WATERBURY FILING NO. 1
GRADING EROSION CONTROL PLAN
INITIAL EROSION CONTROL PLAN 2

GRADING EROSION & STORMWATER CONTROL PLAN
INTERIM EROSION CONTROL PLAN 2

WATERBURY FILING NO. 1

WATERBURY WEST CHANNEL (HAEGLER RANCH TRIBUTARY 1) PLAN & PROFILE VIEW
 HORZ SCALE: 1"=100' - VERT SCALE: 1"=10'

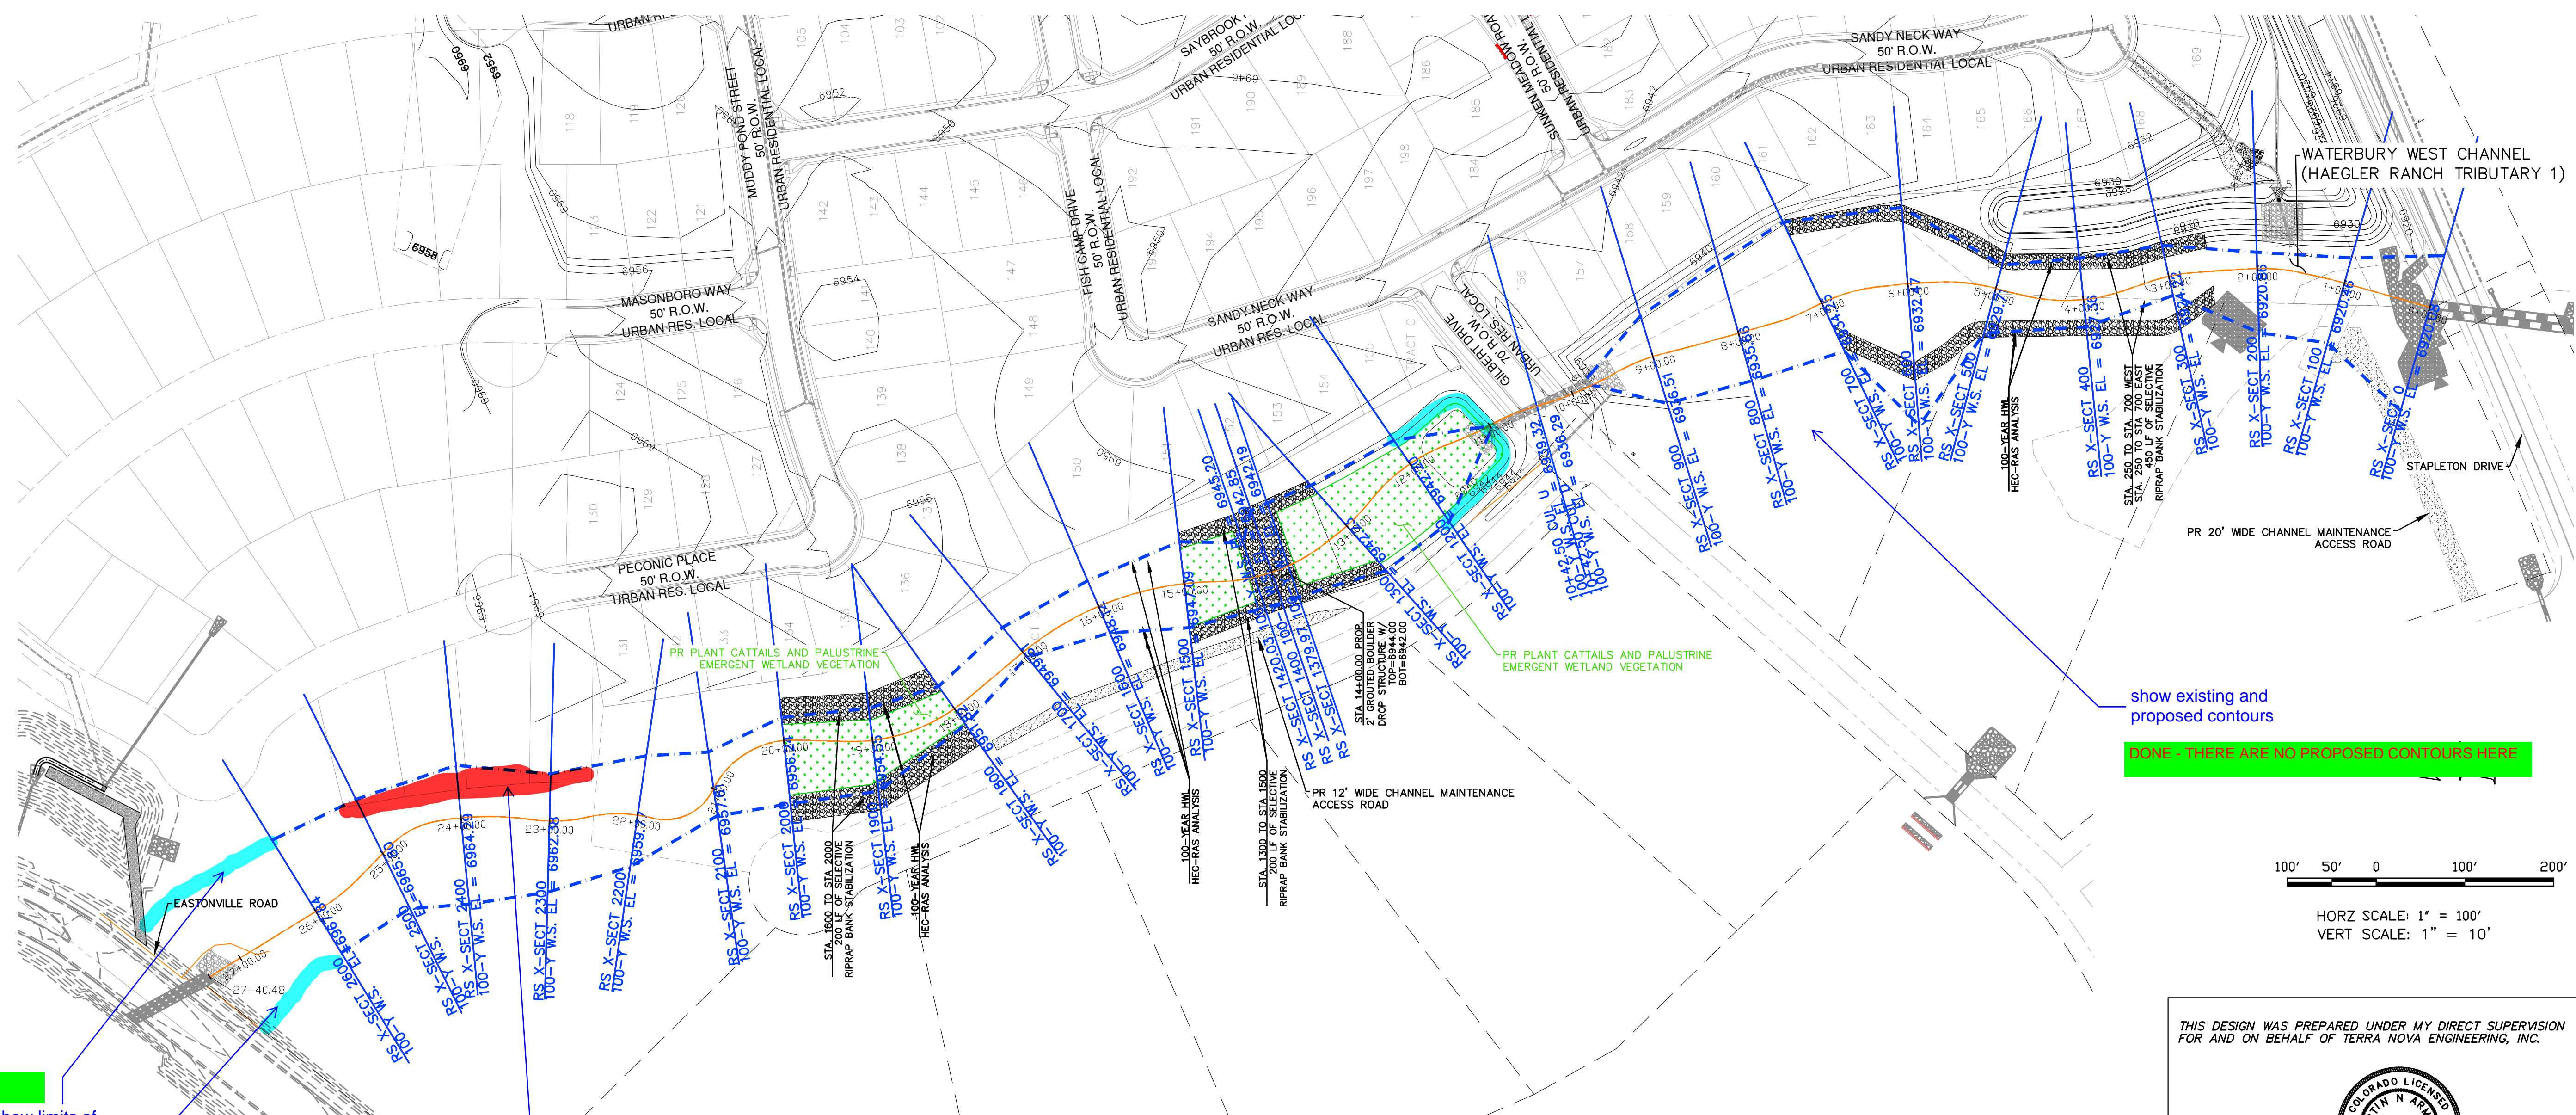
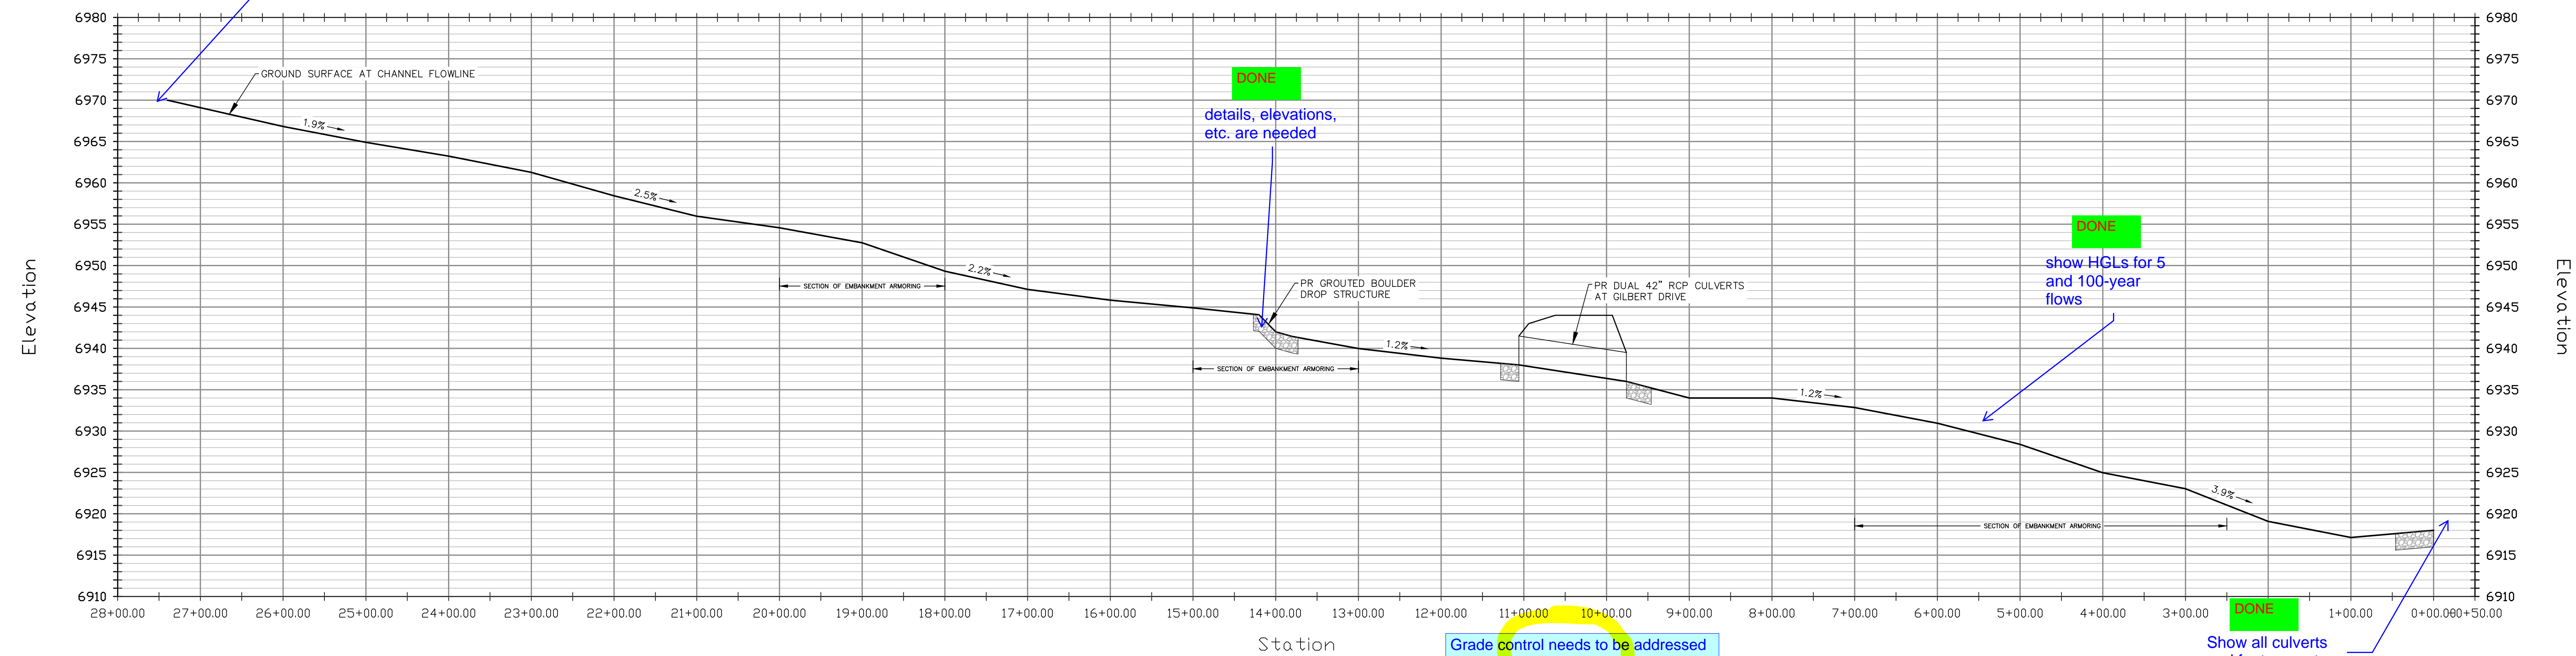
show existing and proposed contours
 DONE - THERE ARE NO PROPOSED CONTOURS HERE

DONE
 Show limits of floodplain

DONE
 Show all culverts and features, etc.

DONE
 details, elevations, etc. are needed

DONE
 show HGLs for 5 and 100-year flows

Show all culverts and features, etc.

Provide a P&P for the east channel also.
